Aillio Technology Co., Ltd
www.aillio.com
support@aillio.com

We recently discovered that there's a step missing in the installation guide. The cooling tray connector has changed from 5-pin to 3-pin:

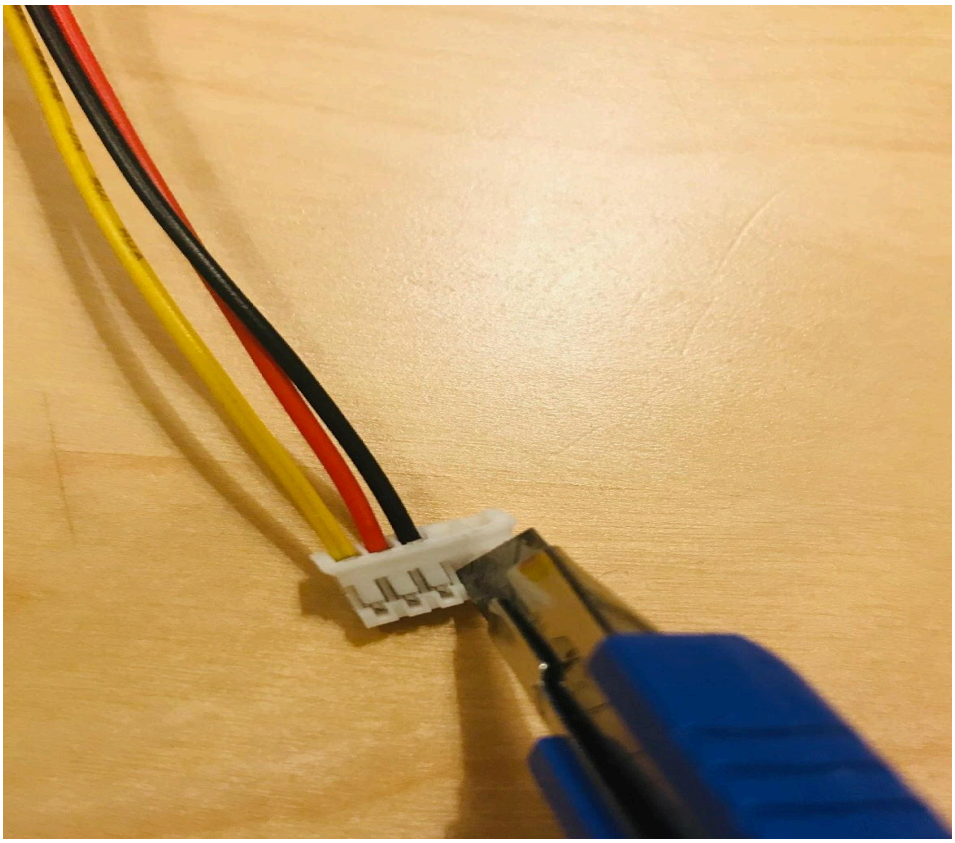
Please make sure you insert the knife at the correct position, leaving a 'wall' for the black wire:

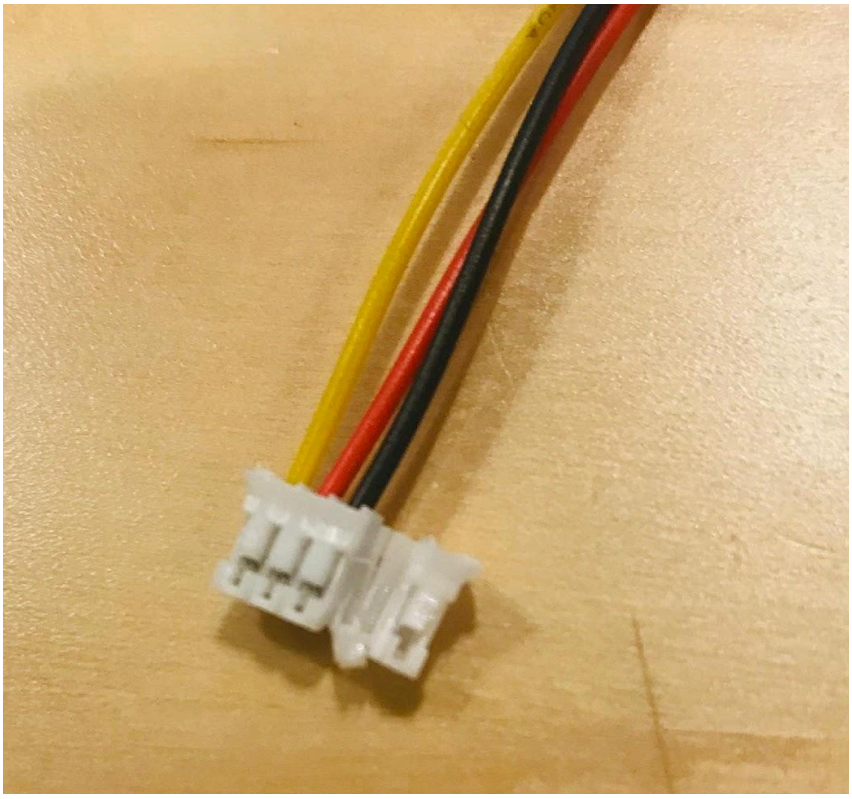
As you cut, it should look like this:

There may be some loose plastic on the side. You can clean it up with the sharp edge, so that it can be fitted into the 3-pin connector.
